# Metropolitan Branch Trail Upgrade

Preliminary Design Report  
May 2023

**Figure 4 - Porous Flexible Pavement Section (Flexipave, Perky pave or Equivalent)**

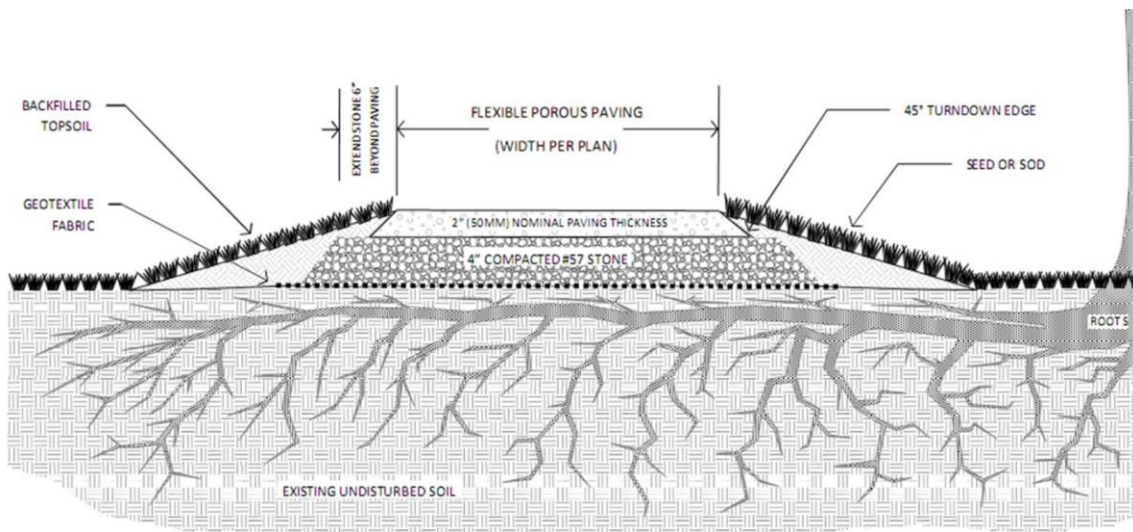
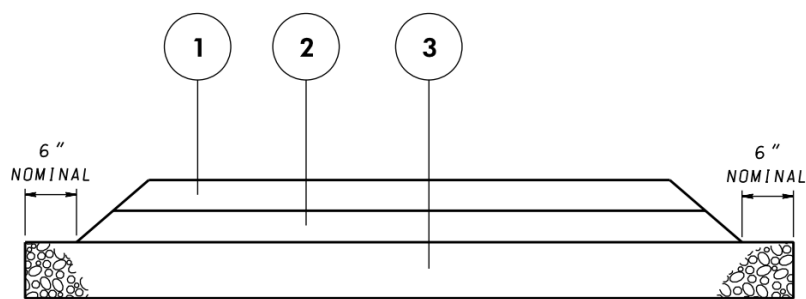
The City of Takoma Park and M-NCPPC requested that the draft 30% design be revised to include traditional asphalt pavement, to remove the large Maple trees causing trail pavement cracking and heaving, and to reduce the buffer space between the roadway and the trail to achieve an 11 feet wide trail (typical). It was requested that bikeway barrier is used to replace the existing wooden fence that separates the trail from the curbed-section roadway between Sta. 54+75 and Sta. 58+50. The City and M-NCPPC also requested that bikeway barrier is provided where recommended by AASHTO guidelines.

Project:	Takoma COGTLC Metropolitan Branch Trail		
Date:	April 2023		
Reviewer:	MNCPPC		
Comment ID	Sheet No. / Drawing No.	Comment	Response
1	General	The porous flexible paving proposed for this bikeway is not the preferred choice for a regional bikeway/breezeway. Surface should "meet requirements of public road design, [with] surface materials and maintenance practices that maximize surface smoothness and pavement life, minimizing potential for pavement cracking and buckling" (Bicycle Master Plan, p 72). If providing a porous surface, porous asphalt would be consistent with the material used in the District's section of this trail, and a more acceptable choice. However, to maintain the permability of porous asphalt, annual maintainance and cleaning is needed. If that maintainance cannot be provided, then this negates the permability, and a regular asphalt surface material would be a better option. At a minimum, any surface should meet the guidance in the AASHTO Bicycle Facilities Guide (2012) on page 5-25.	Porous flexible paving was recommended (draft 30% design) to help preserve trees and to limit the potential for cracking and buckling of the trail pavement. To clarify, porous flexible paving (not porous asphalt) was used in the District's section of this trail. Continued use of a traditional asphalt pavement for the trail adjacent to established trees still has potential for cracking and buckling. Use of porous asphalt will also require more excavation to install, which may be a concern due to the proximity of adjacent established trees. As directed by the City of Takoma Park, the pavement section was changed from porous flexible paving to traditional asphalt.

The revised 30% design (Appendix C) is generally consistent with the Montgomery County Bicycle Master Plan and meets AASHTO guidelines. The design provides an 11-foot wide trail with a 3-foot wide minimum buffer separated by a continuous barrier (curb) between the eastern side of the trail and the road. The western side of the trail has a variable width shoulder. The trail slope is 2% maximum towards the roadway and the slope of the shoulders are 6:1 maximum throughout the project limits. A 500 feet long segment of the trail was reduced to 10 feet wide from approximately station 63+25 to 68+20 to avoid impacts to an existing retaining wall owned by CSX / WMATA along the western edge of the trail. As requested by the City and M-NCPPC, bikeway barrier is proposed to replace the existing wooden fence between Sta. 54+75 and Sta. 58+50. However, it should be noted that the proposed 3-foot minimum separation with 6:1 maximum slope between the edge of the trail and the back of vertical curb, as well as the low-speed context of Takoma Avenue is adequate to meet AASHTO Guidelines without bikeway barrier. As recommended by AASHTO, bikeway barrier is also proposed on the western side of the trail to protect trail users from the drop off area from approximately station 65+40 to 67+00.

ROADWAY PLAN			
SCALE	1"=20'	DATE	MAY 2023
CONTRACT NO.	21-093-TLC		
DESIGNED BY	AMA	COUNTY	MONTGOMERY
DRAWN BY	MEG	LOGMILE	
CHECKED BY	RJG		
F.A.P. NO.	T.B.D.		
DRAWING NO.	HD - 01	OF	06
SHEET NO.	05	OF	16

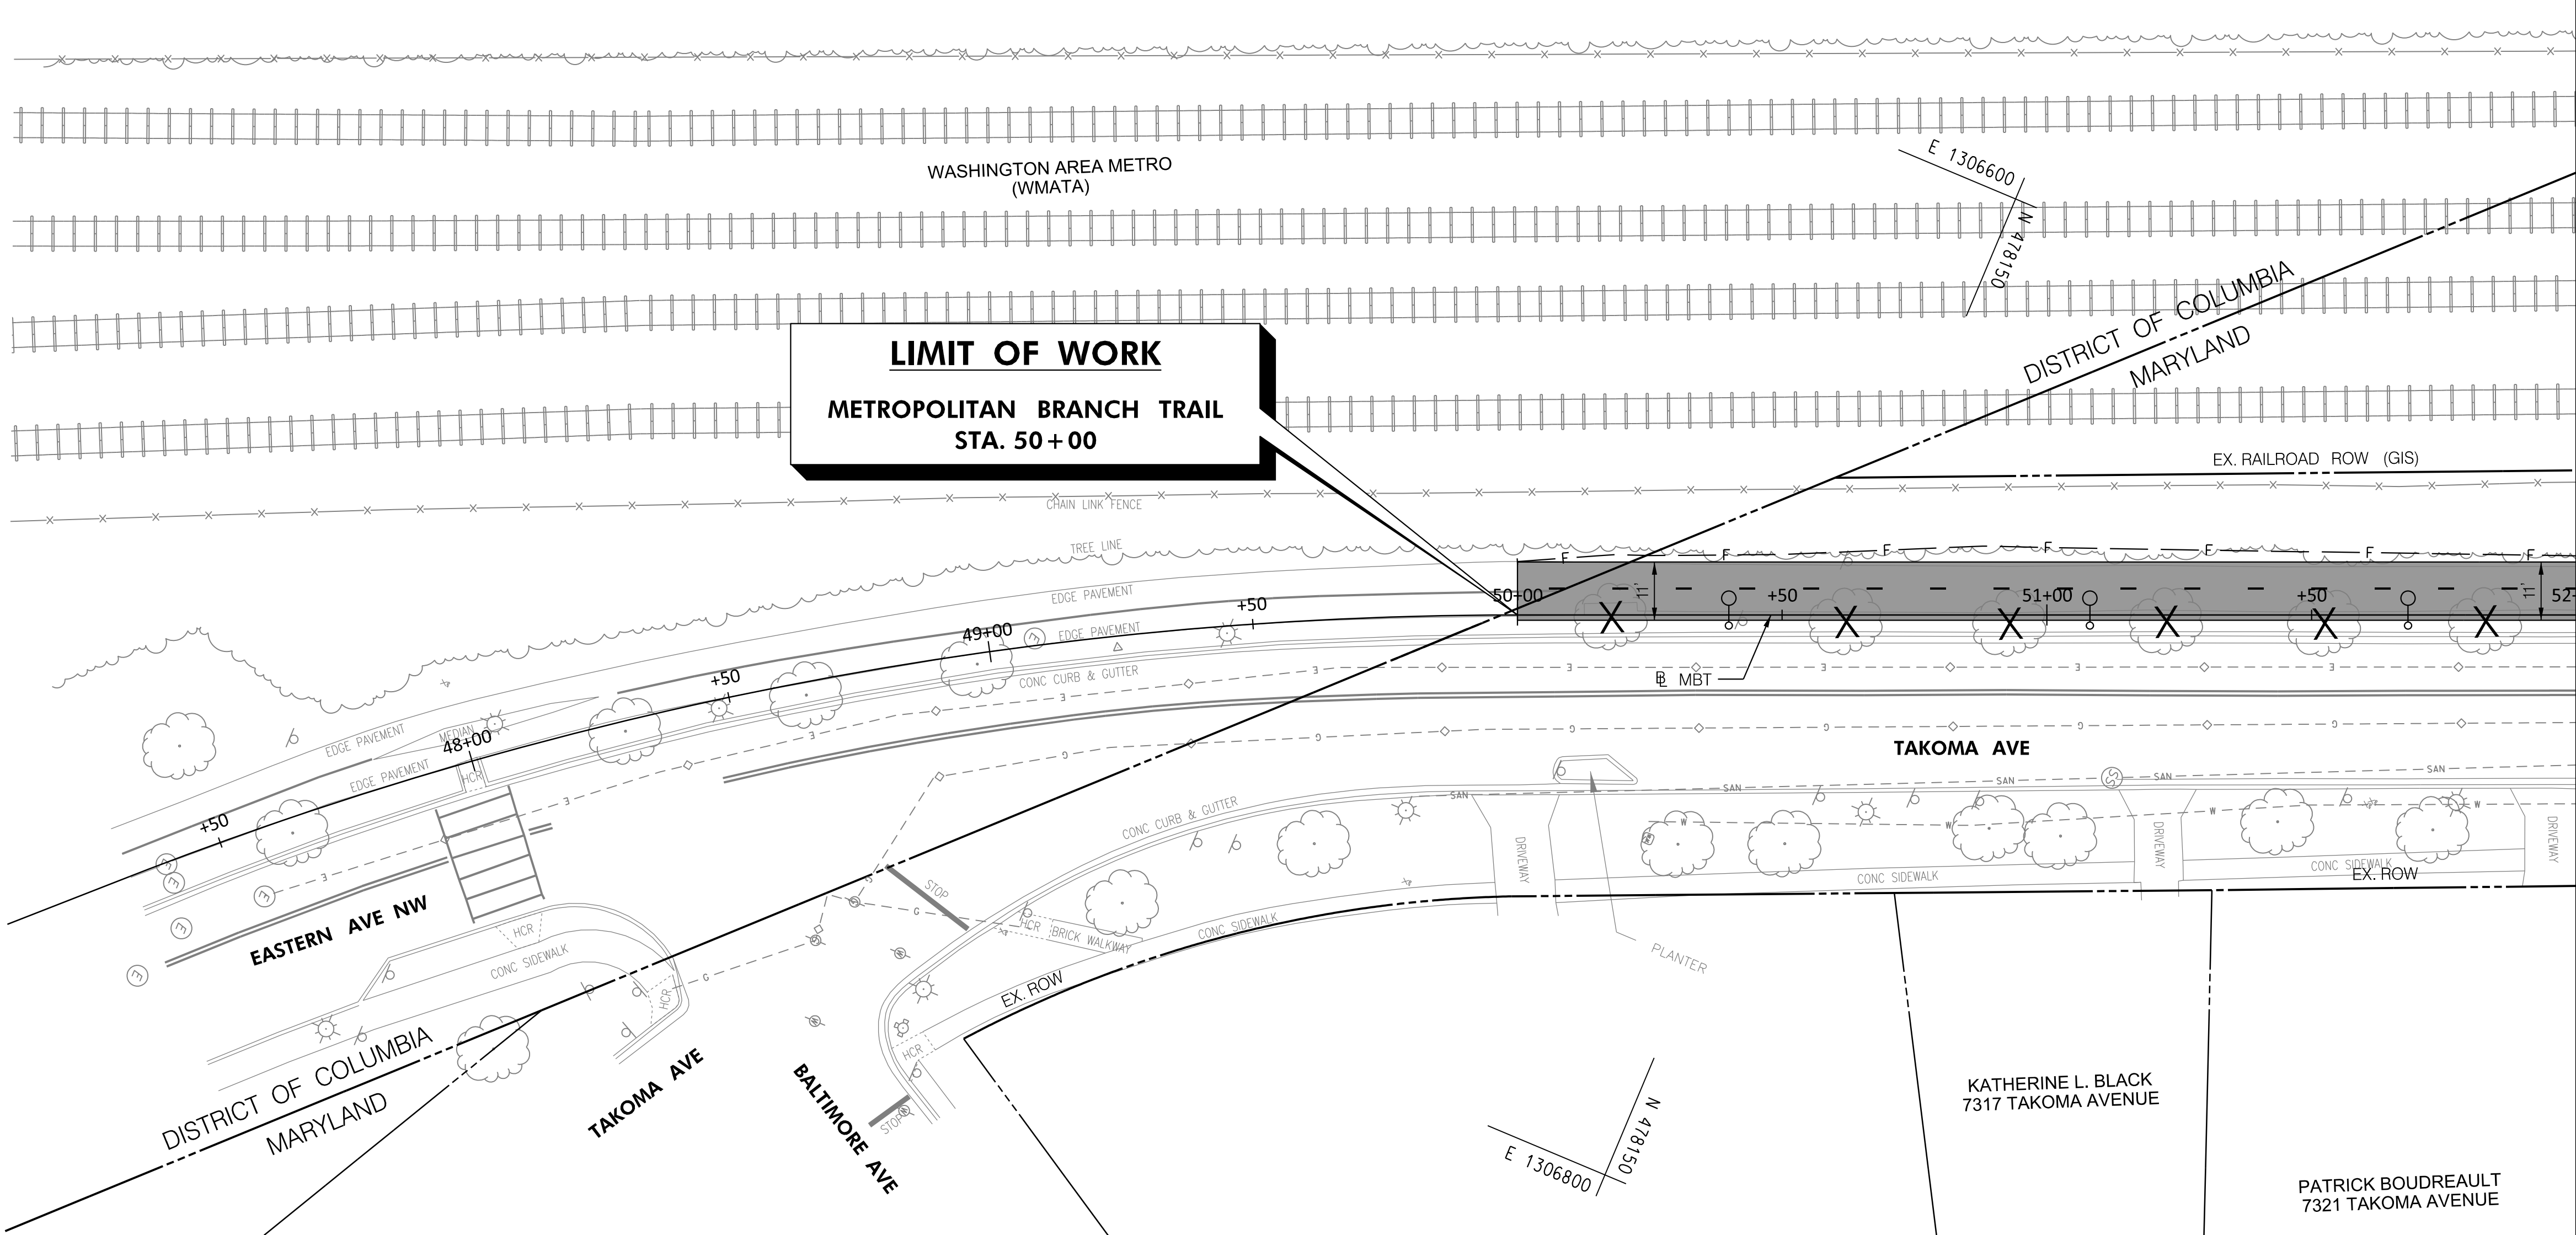
Project:	Takoma COGTLC Metropolitan Branch Trail		
Date:	April 2023		
Reviewer:	City of Takoma Park		
Comment ID	Sheet No. / Drawing No.	Comment	Response
1	HD-01	Public Works expressed concern that having these 'lights' so close to the road invites costly damage from when vehicles bump or collide with them. Would the design work such that they could be placed on the interior? Does that make sense? To me it seem that with the trees, it would be way less likely to happen and they add a note of physical protection to the trail?	It is recommended lighting remains in location shown to avoid unnecessary tree impacts on the opposite side of the trail. Proposed curb will provide protection from vehicles colliding with them.
2	HD-01	Although there is a lot of public feedback in support of porous pavement, PW staff and M-NCPPC staff we spoke with feel strongly that a more durable surface, like asphalt, will be easier and more cost-effective to maintain over time. Apparently it also better aligns with the County's standards for "Regional Breezeways", which this trail has been identified as.	Will use asphalt surface for shared use path.

SCALE	1"=20'	DATE	MAY 2023	CONTRACT NO.	21-093-TLC
DESIGNED BY	AMA	COUNTY	MONTGOMERY		
DRAWN BY	MEG	LOGMILE			
CHECKED BY	RJG				
F.A.P. NO.	T.B.D.				
DRAWING NO.	HD - 03	OF	06	SHEET NO.	07 OF 16

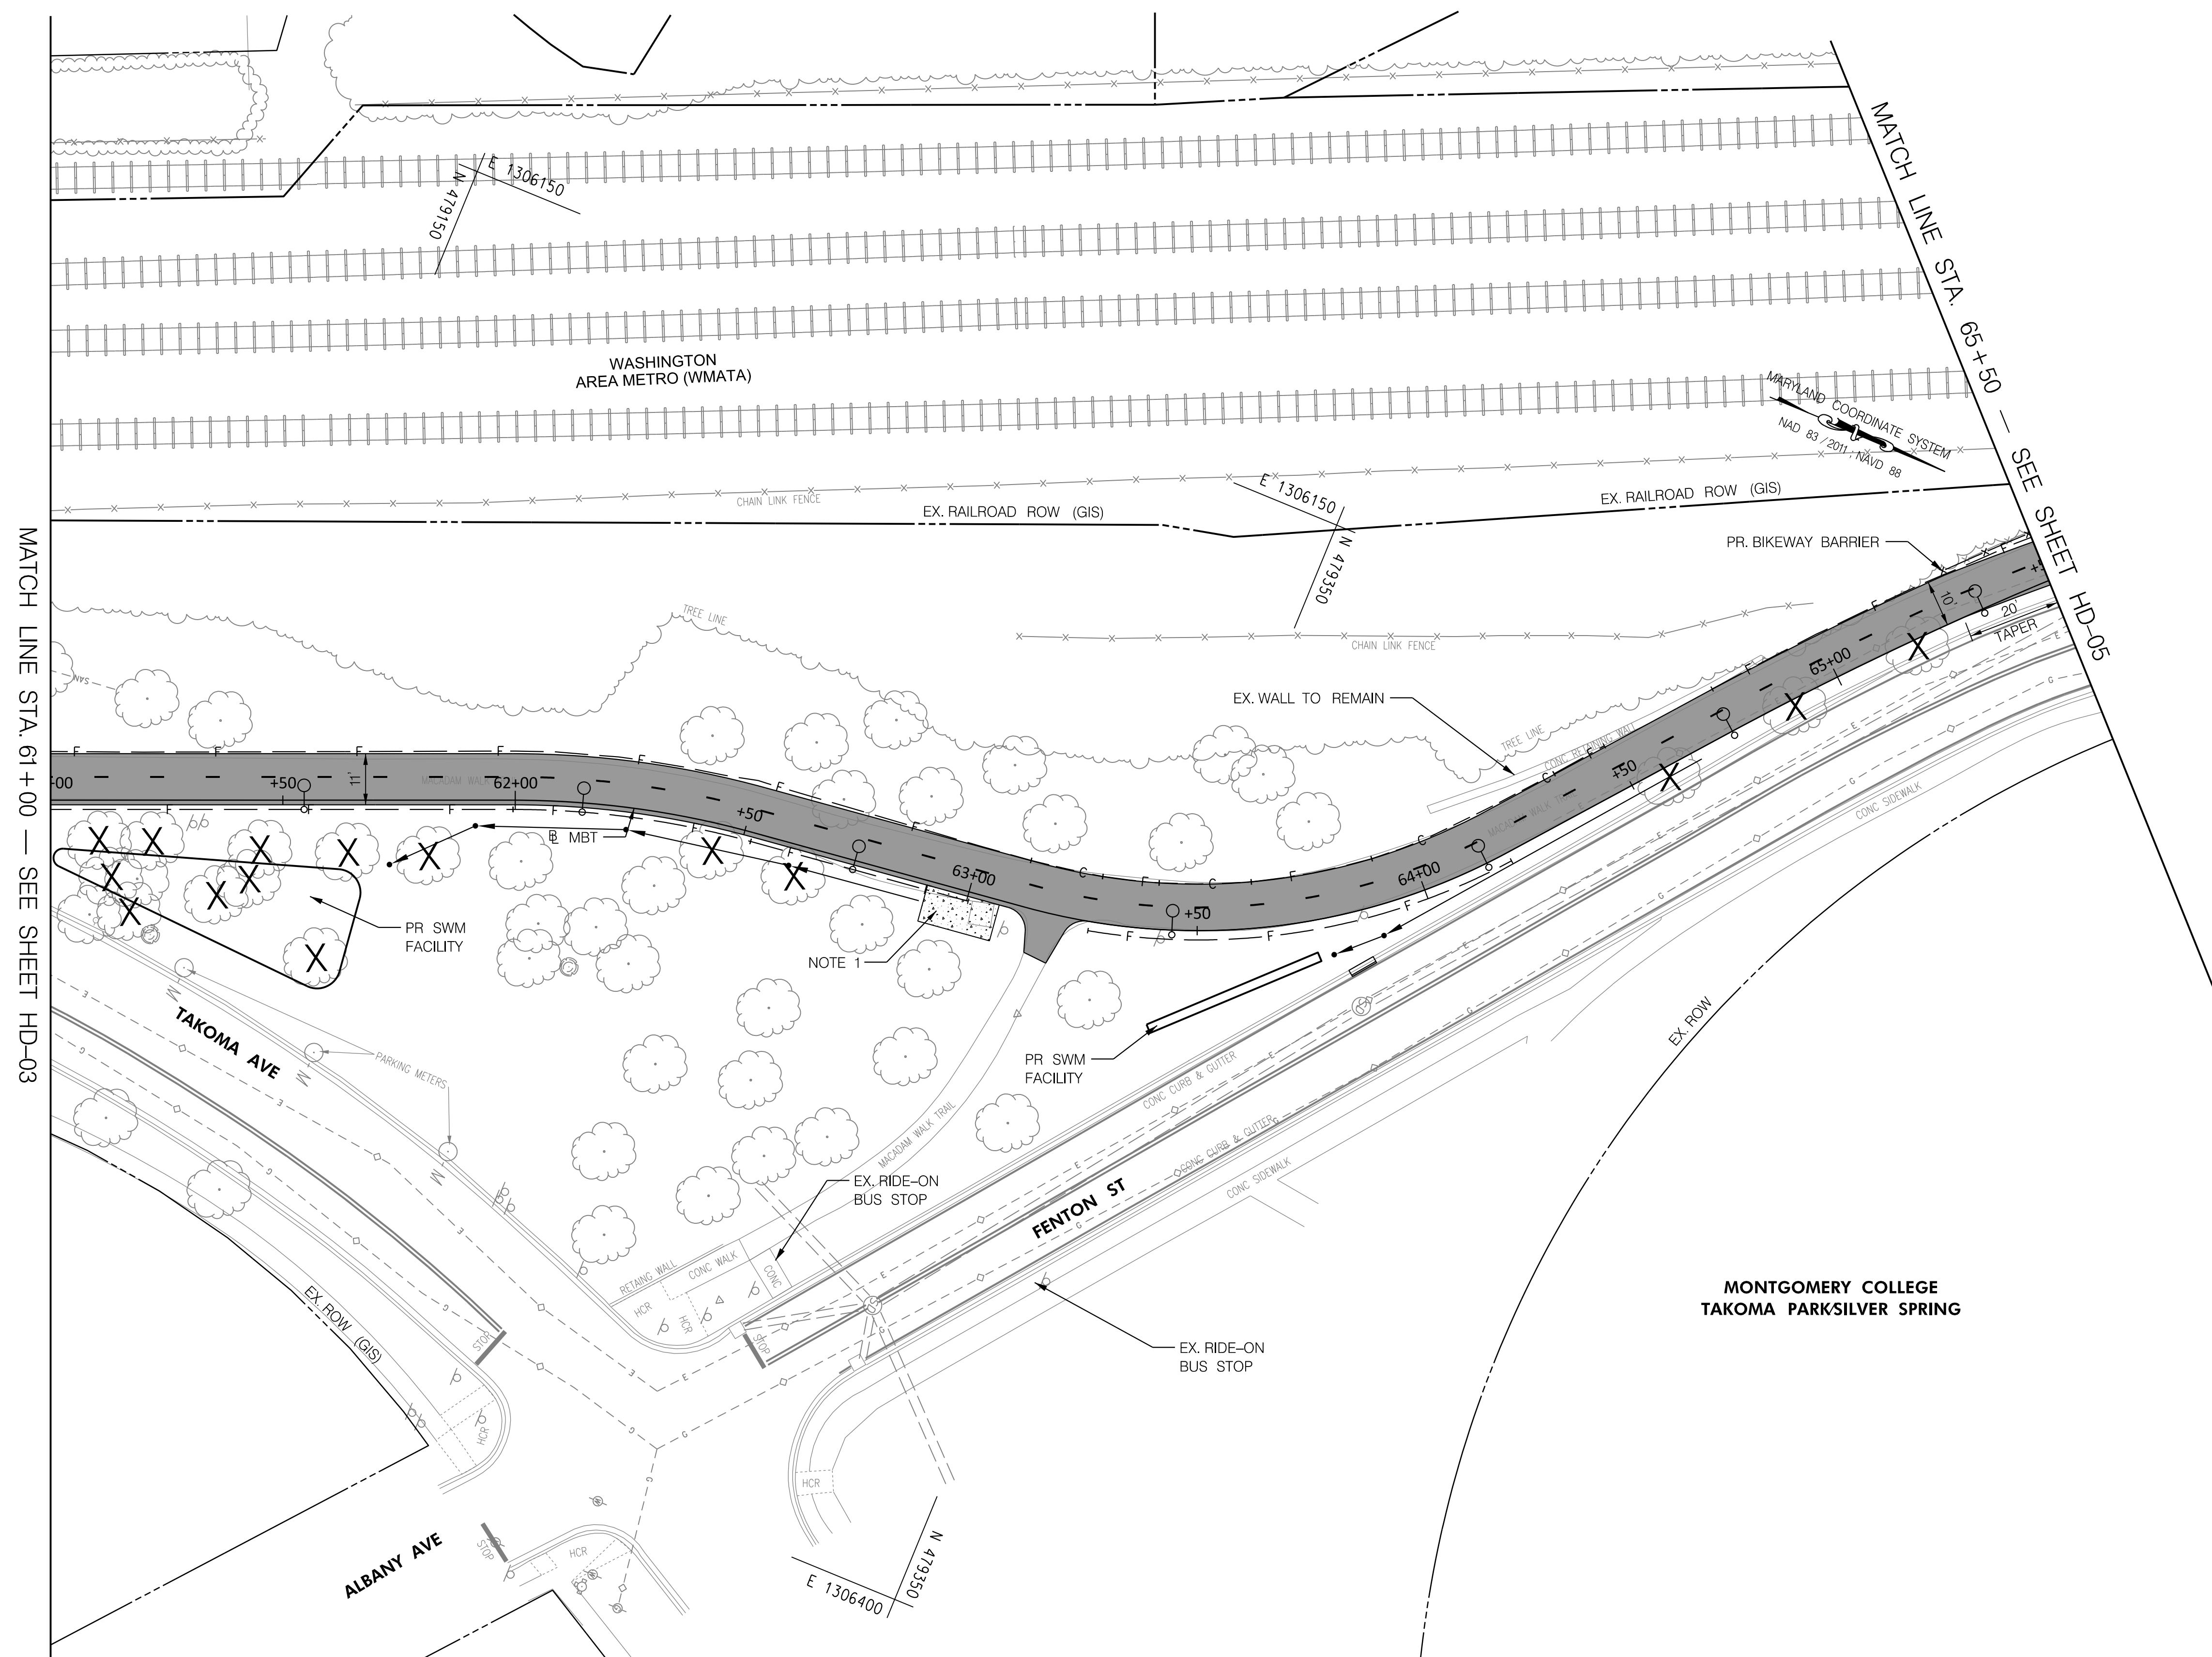
7	HD-04	I also recommend the striping of four-quadrant crosswalks at the intersection of Fenton Street & Takoma Avenue, though I realize that may be out of scope.	This work is outside the scope for this project. Will record comment for future design stages.
